AAA-Gaithersburg, Subdivision Review Waiver SRW-201301, & Site Plan 820130160

Completed: 07/12/13

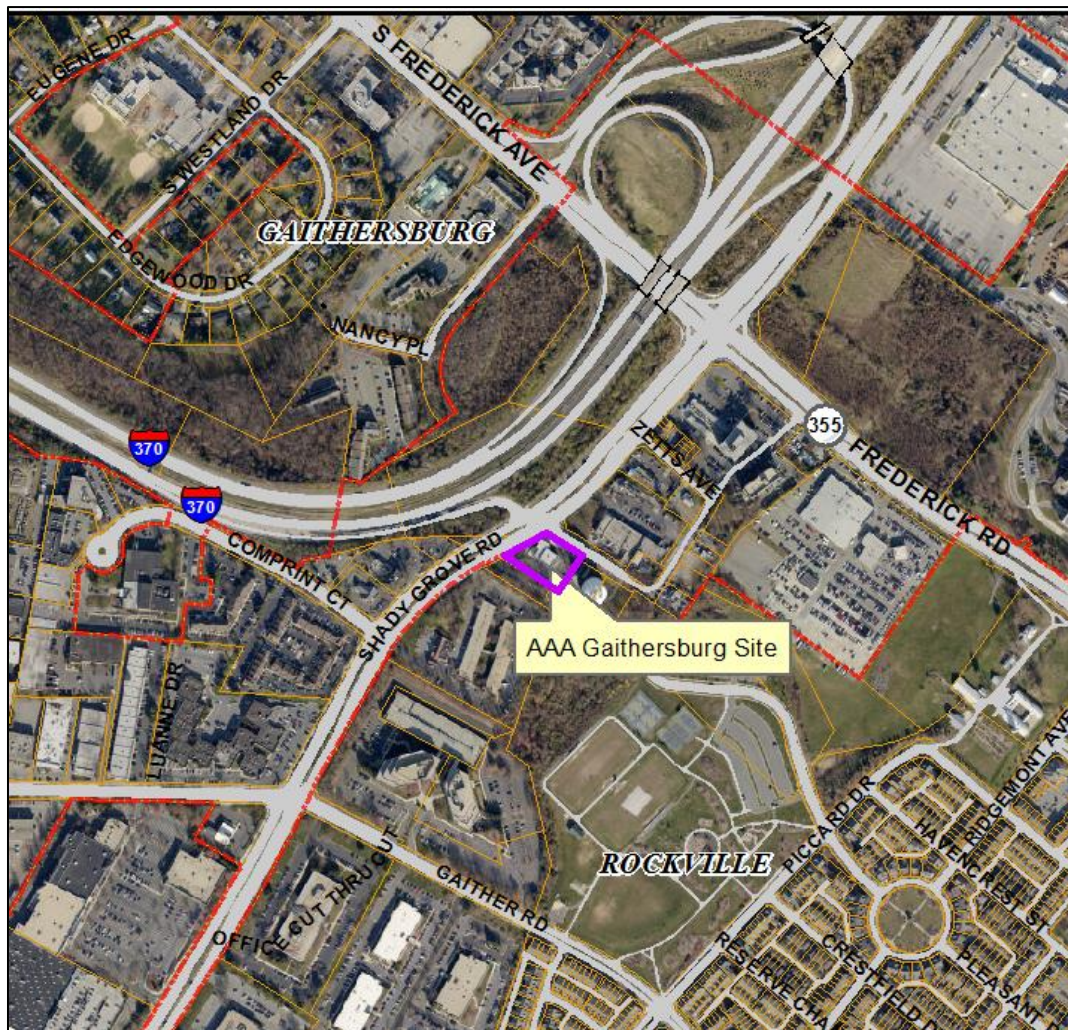
- a. Remove unnecessary sheets, as required by Staff.
- b. Make corrections and clarifications to details, labeling, data tables, and schedules, as required by Staff.
- c. Add a note stating, "Streetscaping improvements in the right-of-way and PIE may be removed or modified by the Montgomery County Department of Permitting Services or Montgomery County Department of Transportation without need to amend this certified site plan."
- d. Delineate the 15-foot wide PIE along the site's entire Shady Grove Road frontage.
- e. As in the July 8, 2013 e-mail from the Montgomery County Department of Permitting Services (DPS), the Applicant must address the following site elements, as approved by DPS Staff:

- All public sidewalks, bike paths and handicap ramps along the site frontage must be ADA-compliant. The handicap ramps must align with the pedestrian crossings on the streets.

- Tractor trailers are not allowed on-site. Proper signage must be provided accordingly. The truck turning movements provided for right-in and right-out movements show possible conflicts with opposite direction traffic. This issue should be further investigated at permit stage and additional restrictions may be implemented.

- Storm drainage study (and possible improvements if needed) and private open space covenant must be provided at permit stage.
- f. Ensure consistency of all details and layout among the site, landscape plans and the Tree Save Plan in #42013195E. Show and label the three specimen trees on and in vicinity of the site, and list the applicable two specimen trees in the Landscape Plan's legend as "to be saved."
